23 April 2020

Re: Proposed Site Remediation
Interim Audit Advice No. 1 – 8-12 University Avenue, Macquarie Park NSW

Attachment A: Remediation Plan

Title: REMEDIATION PLAN	
Location: 8-12 UNIVERSITY AVENUE, MACQUARIE PARK, NSW	
Project No: E29775PL	Figure No: 3
JK ENVIRONMENTS

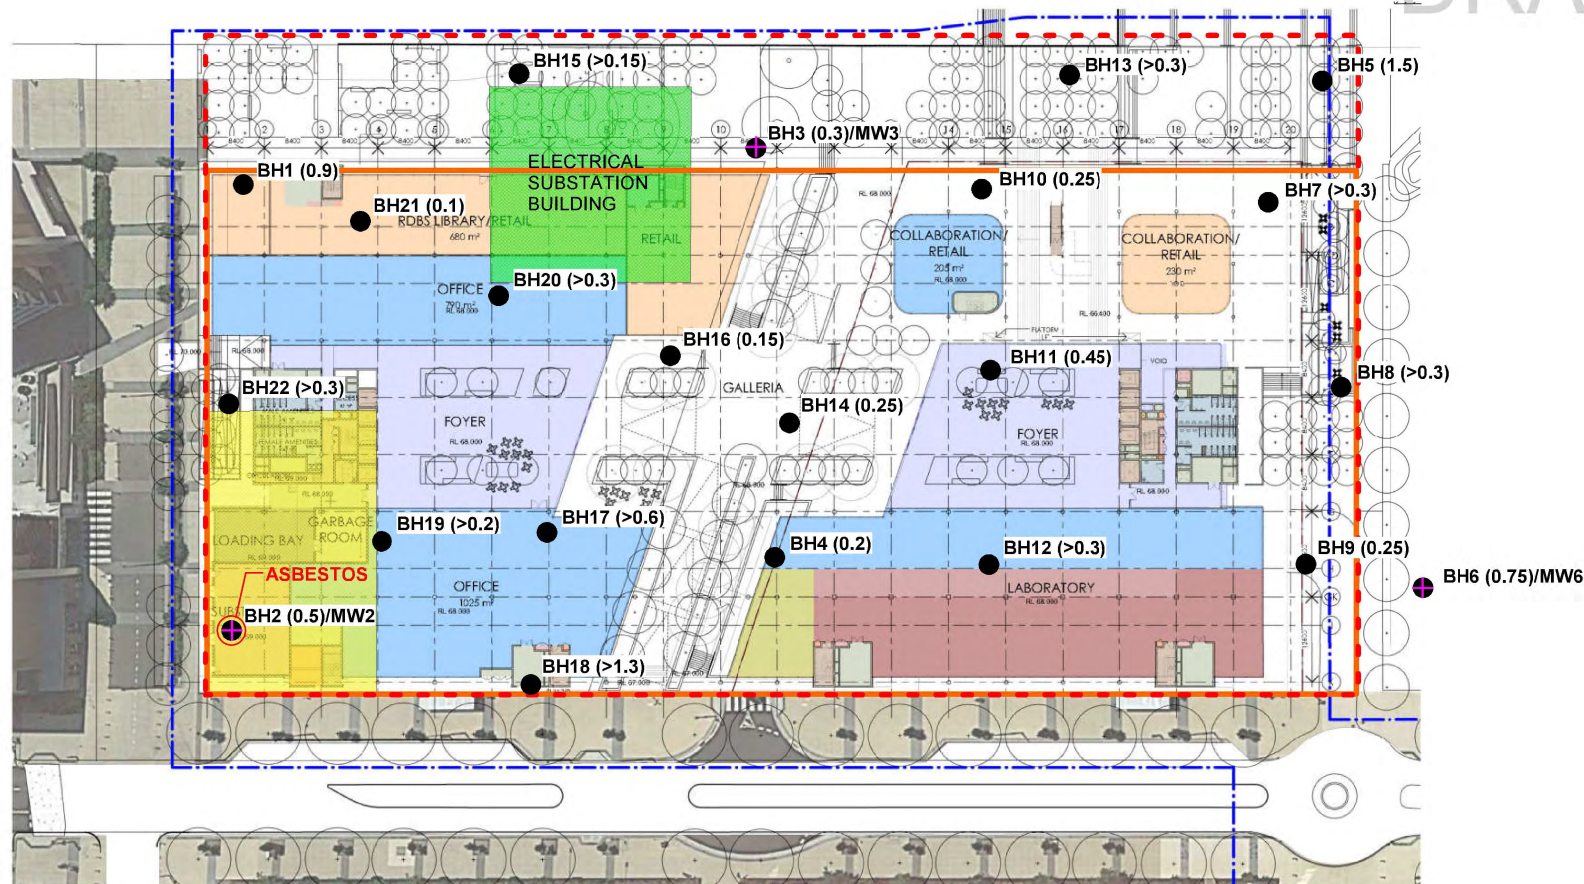
- Section 2.2 Table 2-2. Please state area of the site as is shown by the site boundary in the figures.
- Section 7.2. Table 7-2. Excavation at AEC1 should continue to natural soil.
- Section 8.1.
 - Validation documentation for AEC1 should also include survey plans of the area prior to excavation, following excavation and then at final levels.
 - If possible, VENM should be inspected at the source site by the environmental consultant as well as the receiving site.
 - Please update all asbestos analysis to state 500ml NEPM 2013.
- Section 9.1. Provide an unexpected finds flow chart.
- The RAP will be required to be updated following the data gap assessments. In particular, there is currently no discussion around the remediation requirements for the electrical substation. This is will need to be included in an updated RAP.
